Service Bulletin

Alternator Control Unit (ACU) Replacement & ACU Interface Replacement.

SB-GA8-2017-171

Issue 2

Figure 2 – Caution Unit Tray attachment hole locations. Tolerance ± 0.05 ”

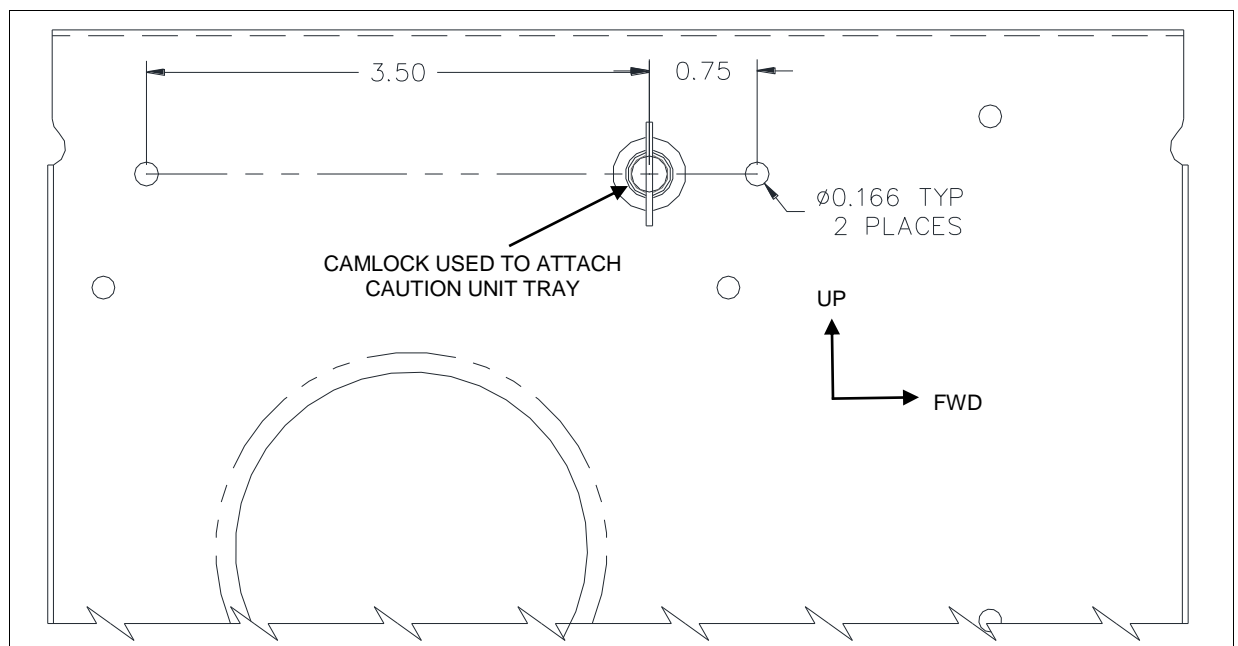
13. Select option below which corresponds to inspection results from Steps 10 and 12, and accomplish the instructions that follow.
 - a. If there are no holes but rivnuts are installed, match drill holes into the Caution Unit Tray using a #19 drill, to a diameter of 0.166". Disconnect the Caution Unit Tray and lower towards the floor.

- b. If there are no holes and rivnuts are not installed, then re-attach Caution Unit Tray via camlock. Drill two holes into the Caution Unit Tray, and the cockpit side wall structure behind, in accordance with Figure 2. Disconnect the Caution Unit Tray and lower towards the floor. Install a rivnut (Item 251) into each of the two holes in the cockpit side wall structure.

- c. If there are holes but rivnuts are not installed, then re-attach Caution Unit Tray via camlock. Match drill the two holes into the cockpit side wall structure behind. Disconnect the Caution Unit Tray and lower towards the floor. Install a rivnut (Item 251) into each of the two holes in the cockpit side wall structure.

Figure 3 – Hole locations for Plane Power voltage regulator.

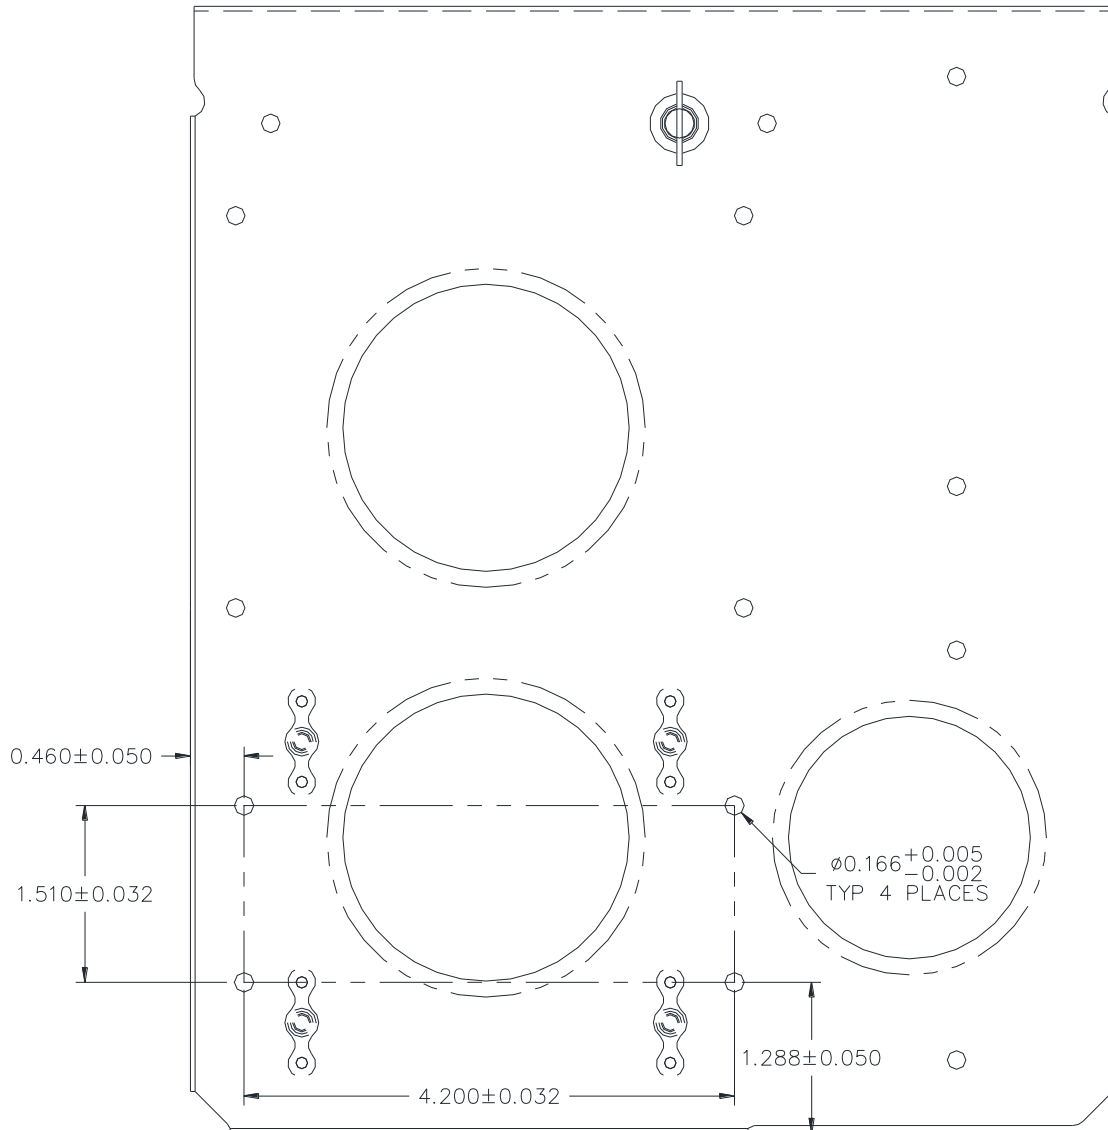
15. Drill four holes into the Caution Unit Tray as specified by Figure 3. Deburr holes.

Figure 4 – Installed voltage regulator. (ACU Interface, Caution Unit and System Controller not shown).

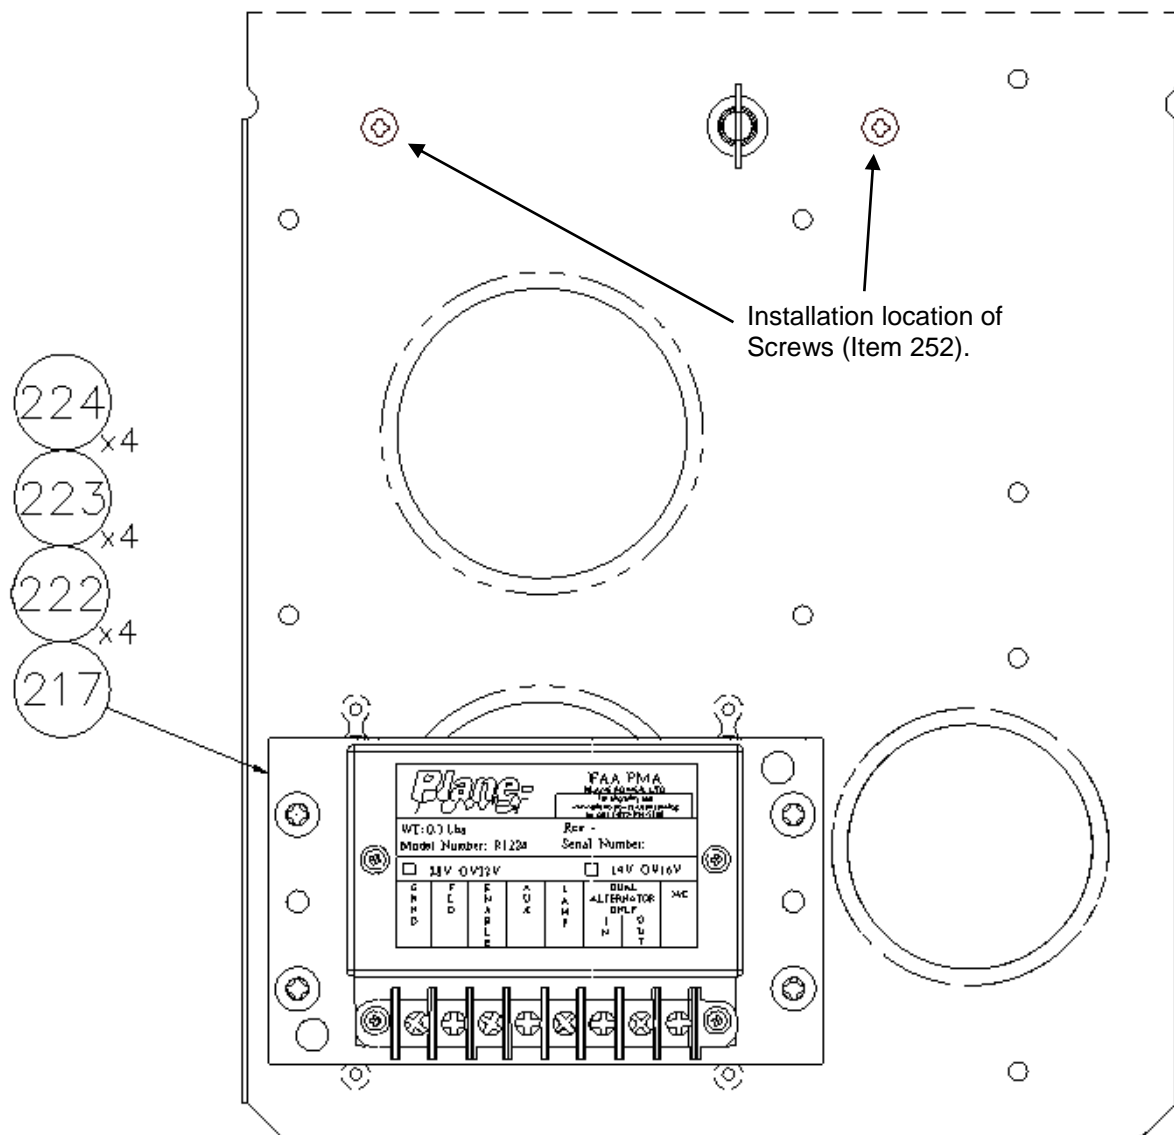
18. Attach the R1224 Voltage Regulator in accordance with Figure 4.
19. Re-wire the aircraft to the R1224 Voltage Regulator in accordance with Figure 9, Figure 10 or Figure 12 as applicable (Refer to Table 6). Attention is drawn to the installation of an AUX circuit as described in Figure 10 or Figure 12.

20. Reconnect all electrical housings to the Caution Unit, System Controller and ACU Interface.
21. Re-install the Caution Unit Tray to the aircraft by fastening Camlock. Install Screws (Item 252) into the two rivnuts in cockpit side wall structure. See Figure 4.

Figure 5 – Installed voltage regulator and relay. (Caution Unit and System Controller not shown).

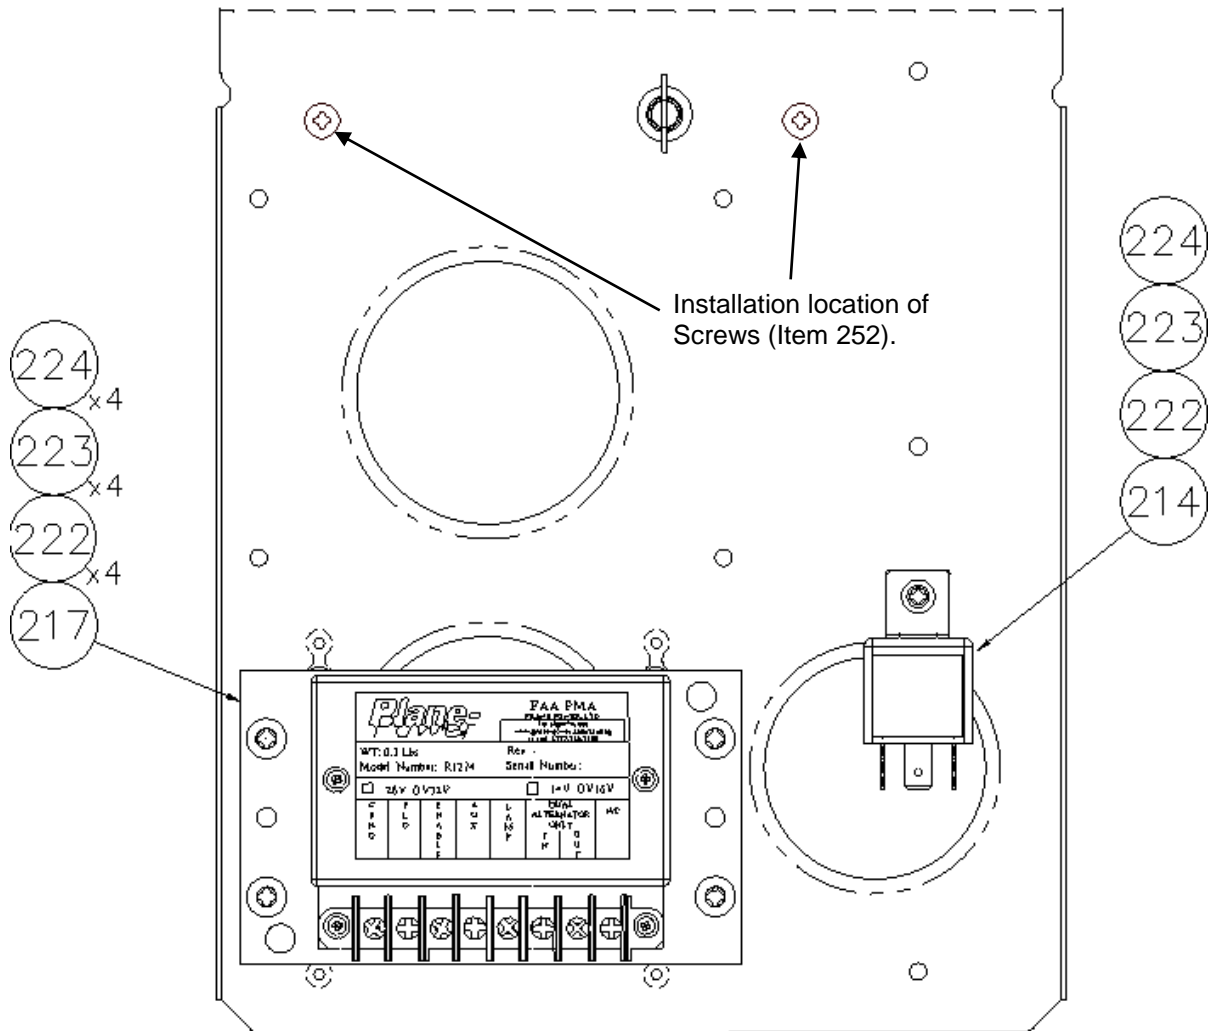
23. Re-wire the aircraft to the R1224 Voltage Regulator and Change-Over Relay in accordance with Figure 11 for the Plane Power ALT-FLX alternator or Figure 13 for the ES-14024B-2 alternator. Attention is drawn to the installation of the AUX circuit.

24. Reconnect all electrical housings to the Caution Unit and System Controller.
25. Re-install the Caution Unit Tray to the aircraft by fastening Camlock. Install Screws (Item 252) into the two rivnuts in cockpit side wall structure. See Figure 5.

Figure 6 – Location of DC/DC Up-Converter. View looking up at roof.

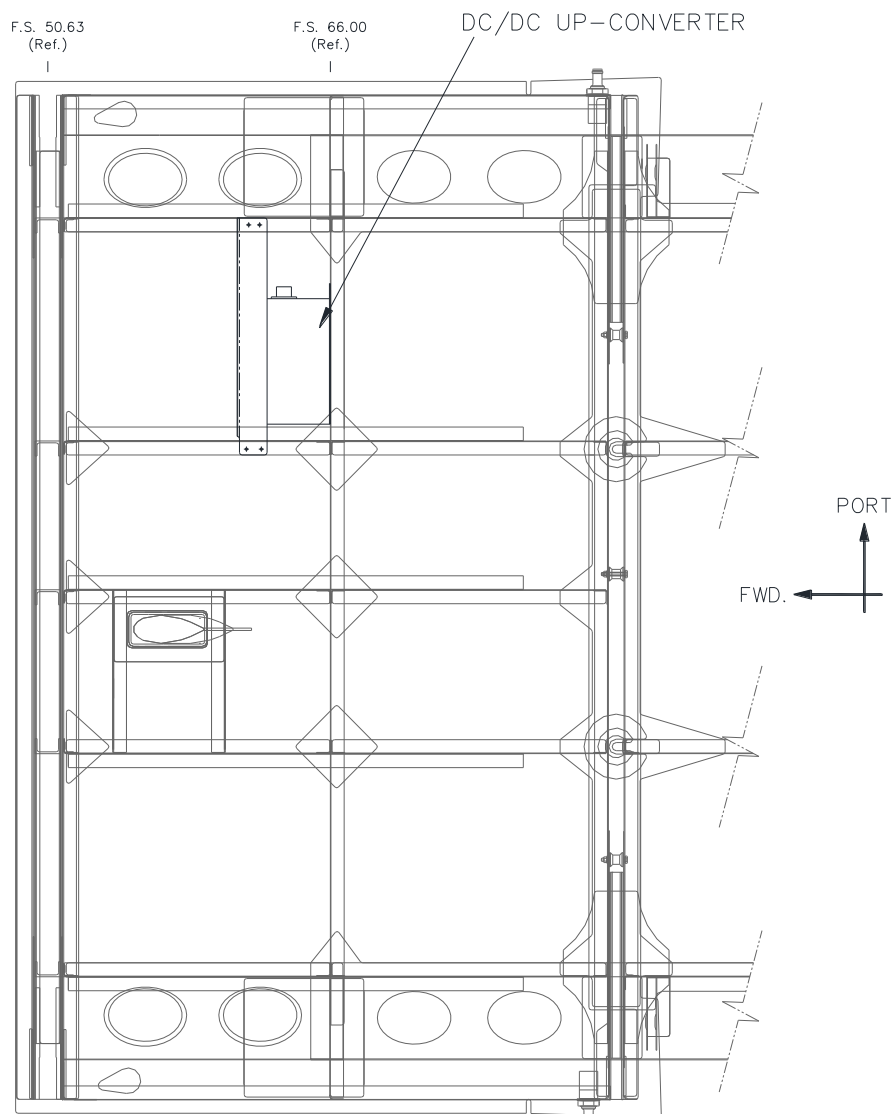
1. To gain access to the DC/DC Up-Converter, remove the roof trim panel immediately aft of the electrical overhead panel. Refer to Figure 6 for location of the DC/DC Up-Converter.
2. Disconnect the electrical connector from the DC/DC Up-Converter.
3. Remove the earth return wire from the DC/DC Up-Converter.
4. Remove the DC/DC Up-Converter unit.
5. Cut off the 3 way connector.
6. Splice circuits 1PG008A18 to the circuit previously connected to Pin C of the DC/DC Up-Converter. The designations will vary. Use Item 250.
7. Cap and stow circuit 1PG008C18.
8. Attach roof trim panel using existing fasteners.

Figure 7 – Unmodified electrical overhead panel.

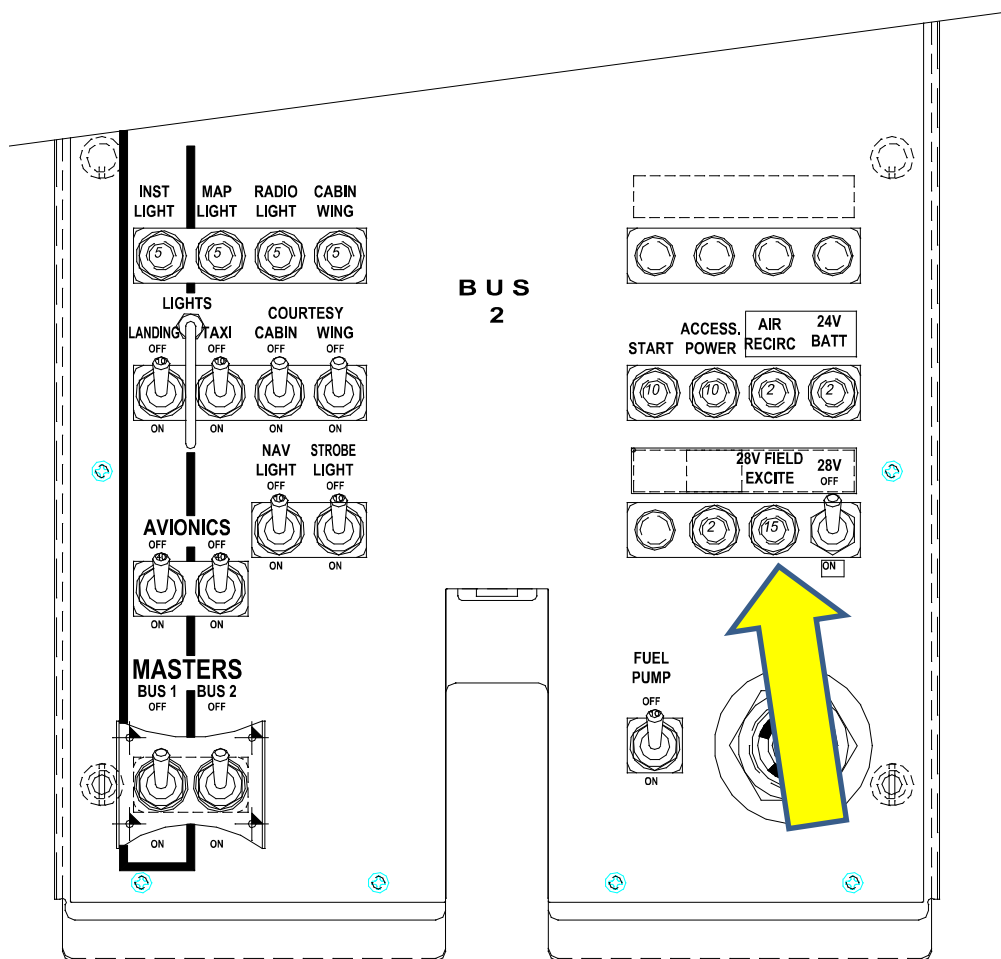
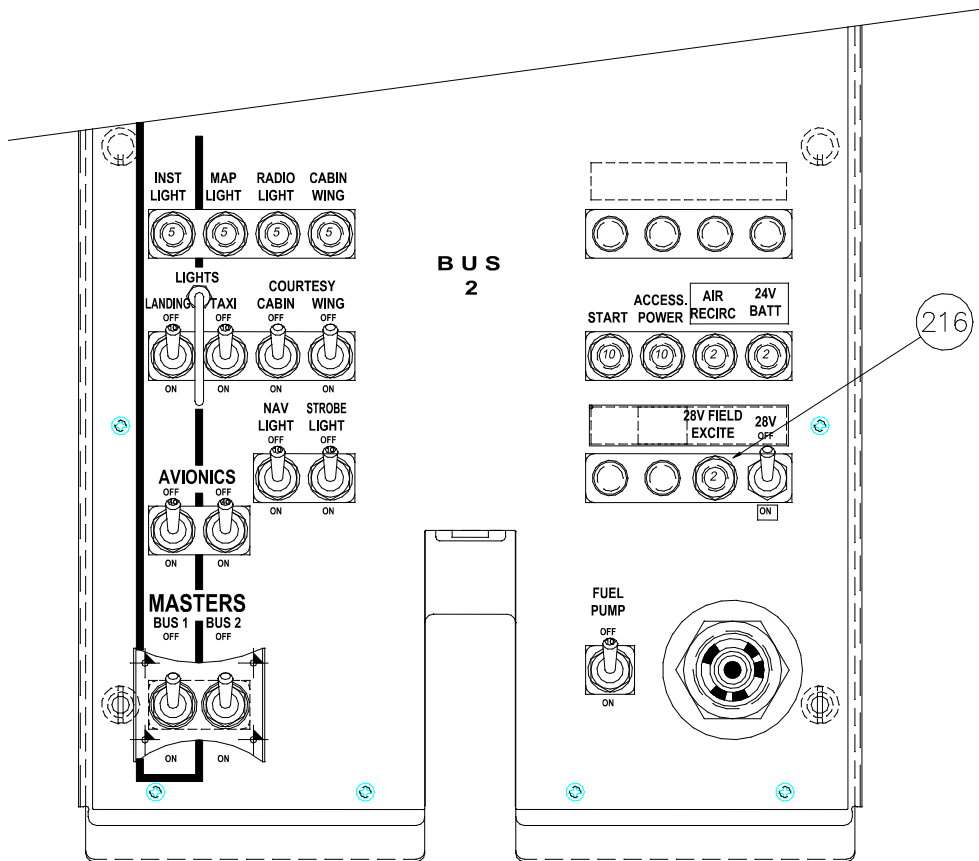
1. Lower the electrical overhead panel in accordance with Section 31-10-00 of the GA8/GA8-TC 320 Service Manual.
2. Remove the installed 15A circuit breaker at the location noted in Figure 7. The placard marking may be labelled either "28V FIELD EXCITE" or "28V MISSION".
3. In this location, install a 2A circuit breaker (Item 216) in accordance with Figure 8.
4. Complete the electrical circuit from the switch to the relay reusing existing wiring.
5. Re-install the electrical overhead panel.

Figure 9 – Wiring diagram with replacement of Zeftronics alternator control unit for SB-GA8-2012-90 or ER-GA8-9624222.

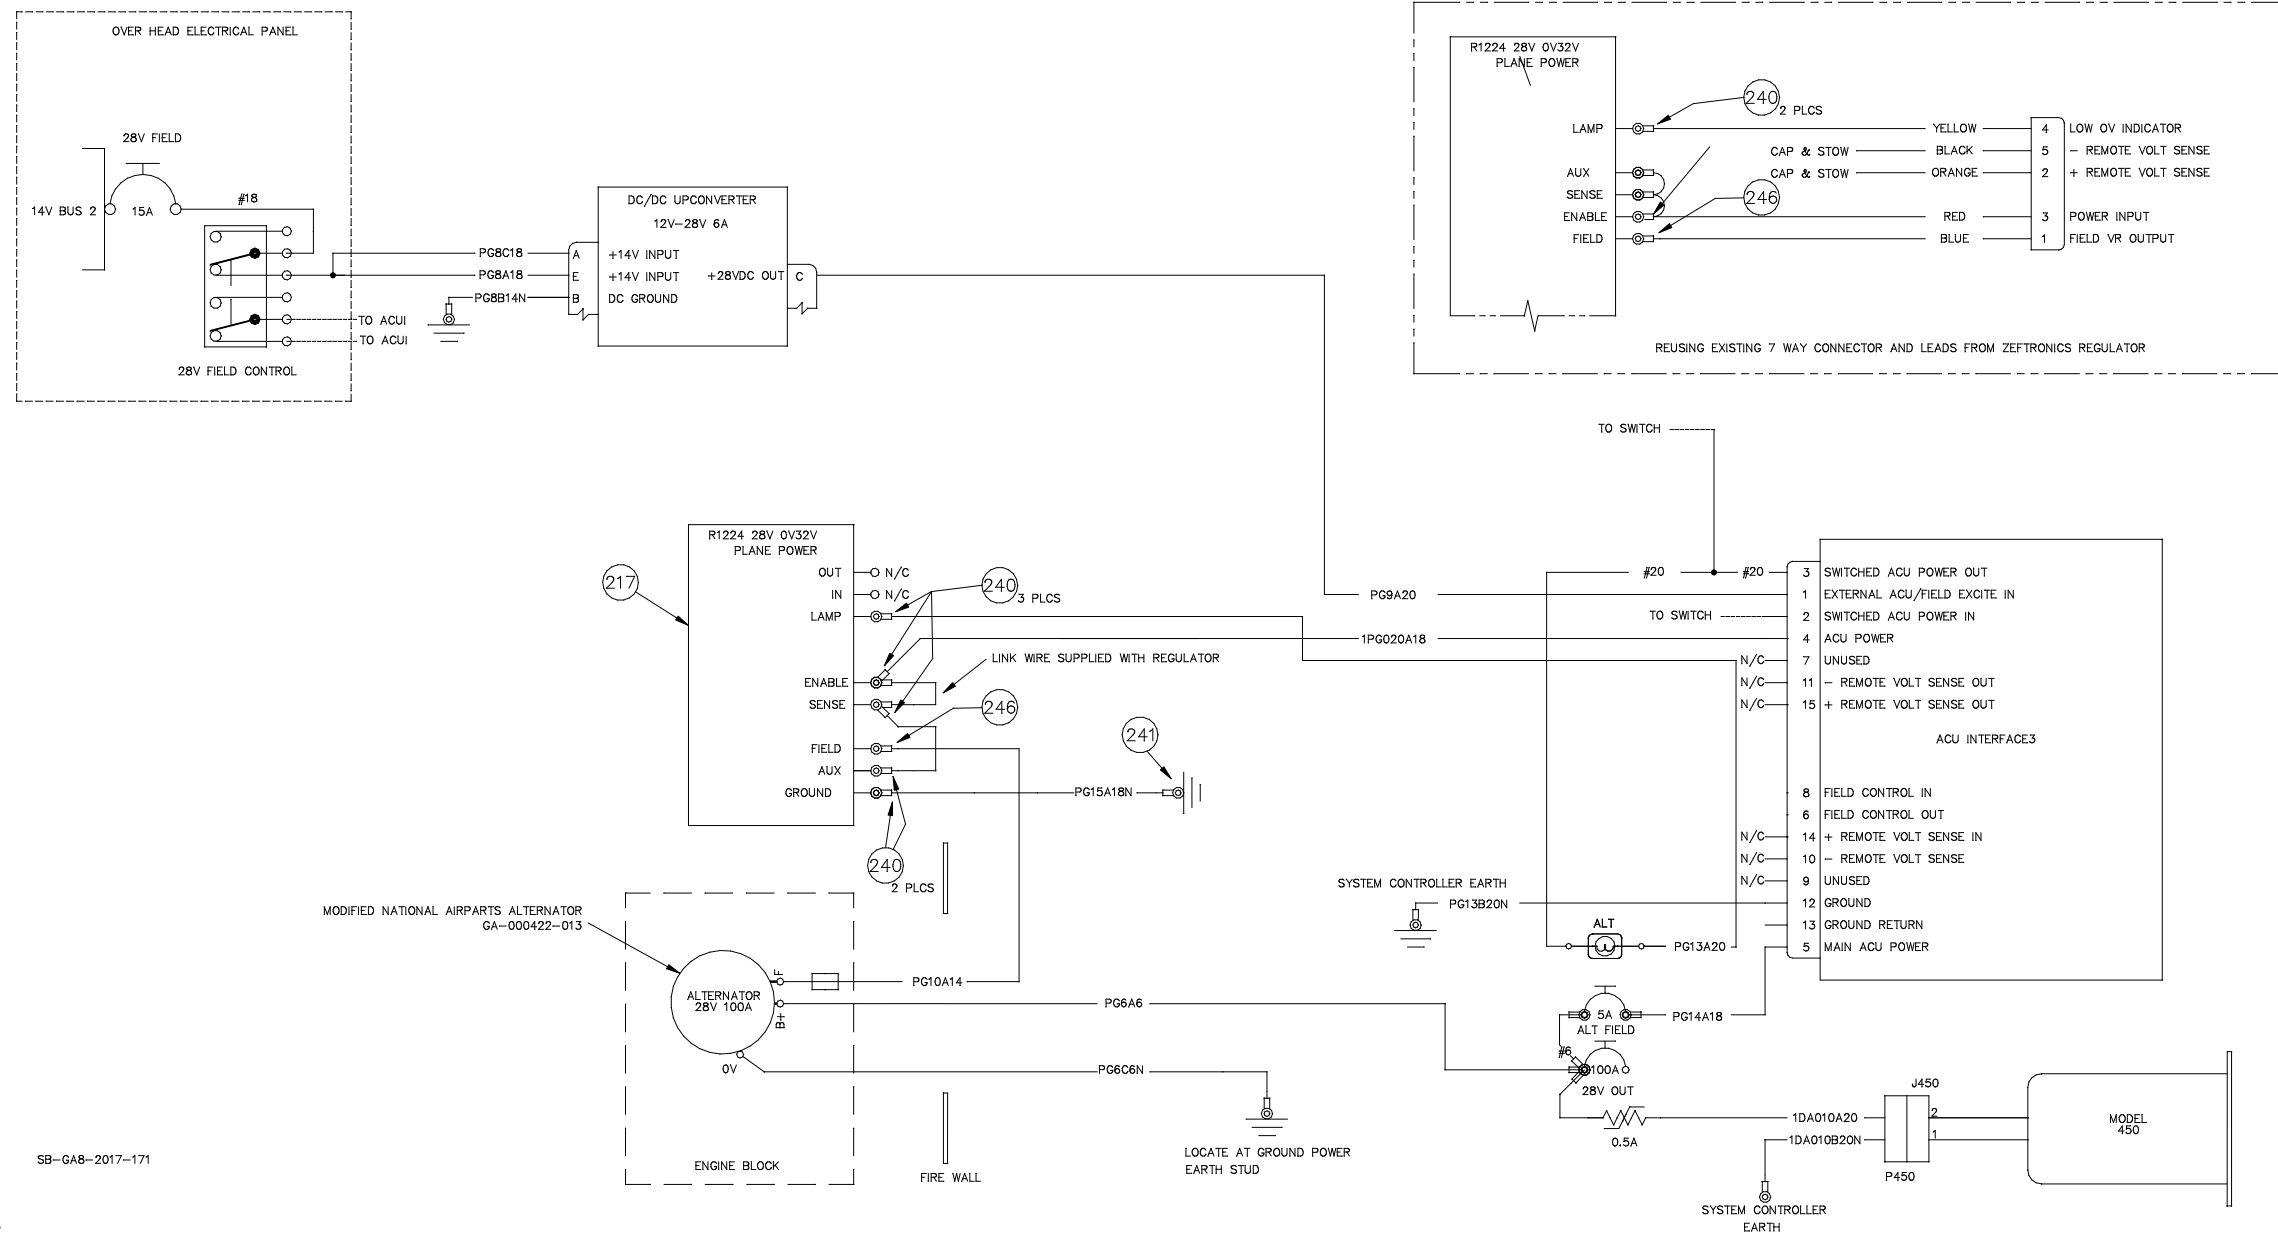
Choose Part A or B from Table 6. Part A will only replace the regulator and, with exception of Figure 9, run a wire from the AUX terminal of the alternator to the AUX input of the voltage regulator.
